**AMENDMENTS TO THE DRAWINGS**

**REMARKS**

Application No. 10/767,988  
Amendment Dated  
Reply to Office Action of October 13, 2005

**FIG - 6**

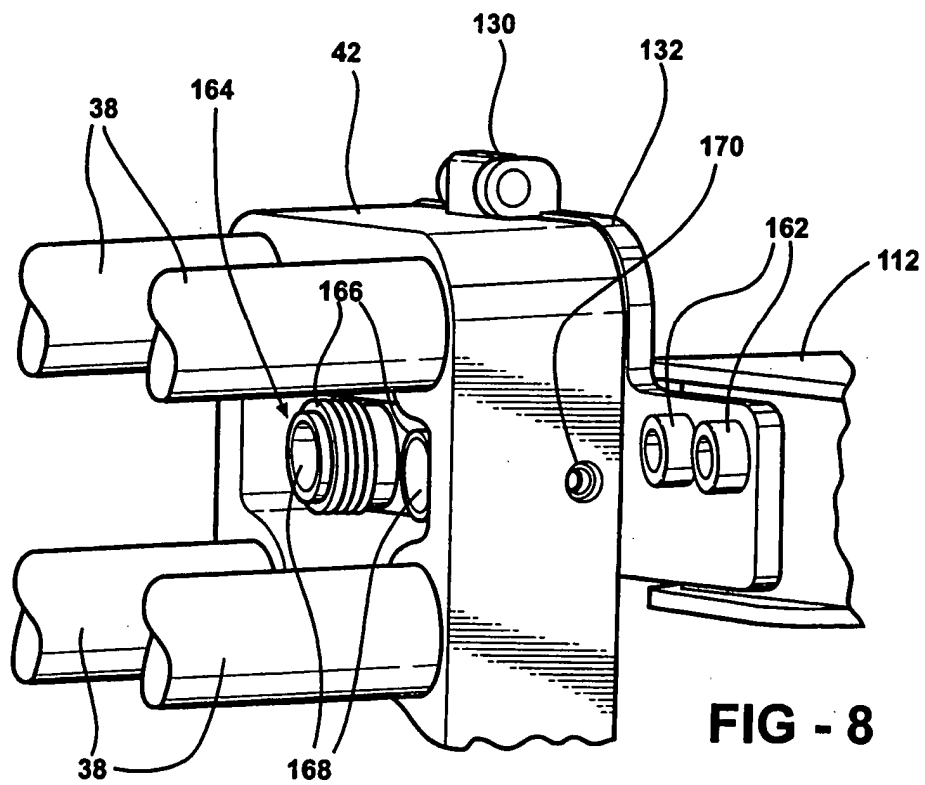
The drawings are also objected to because they do not depict the reference numbers "102" and "126". Appropriate correction has been made by inserting into Figure 6 the reference number 102, and by inserting into Figure 7 the reference number 126. Attached herewith are replacement sheets for Figures 6-8. Also attached are annotated sheets showing the changes to Figures 6 and 7 as described above.

**FIG - 7**

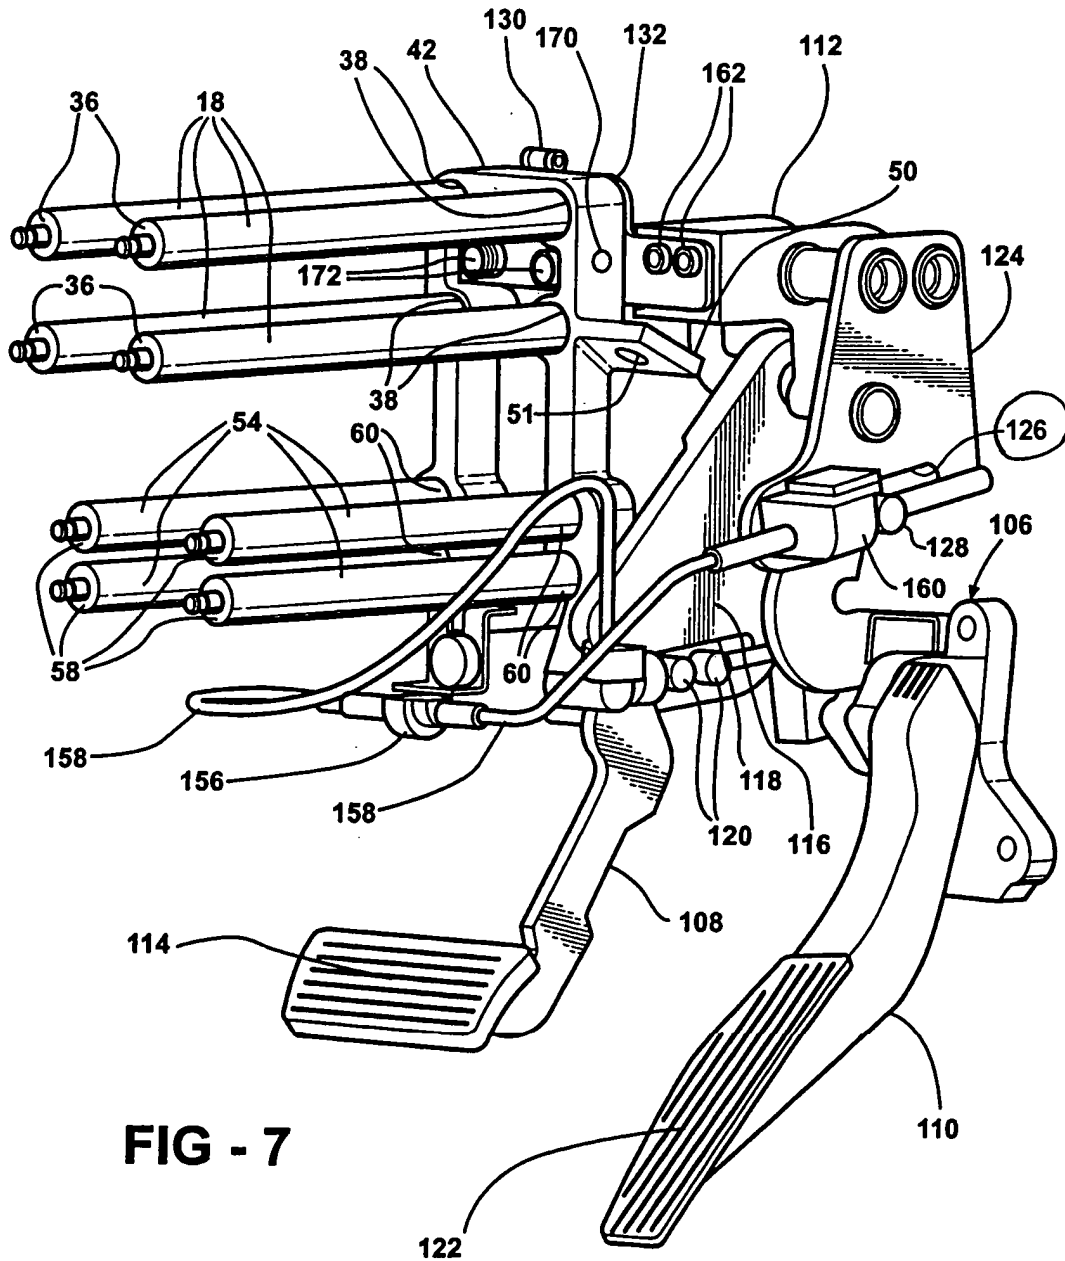
The drawings also are objected to because, in Figure 7, reference character 172 for the pyrotechnic device does not appear any different from what is described and shown in Figure 8

and represented with reference character 168. The Applicant respectfully submits that this is not a drawing issue. The difference between views depicted in Figures 7 and 8 is that reference character 172 refers to the pyrotechnic devices *per se*, which are placed into the chambers 168. The chambers 168 are shown empty in Figure 8. Thus, the pyrotechnic devices 172 are not depicted in Figure 8, as having been removed for clarity.
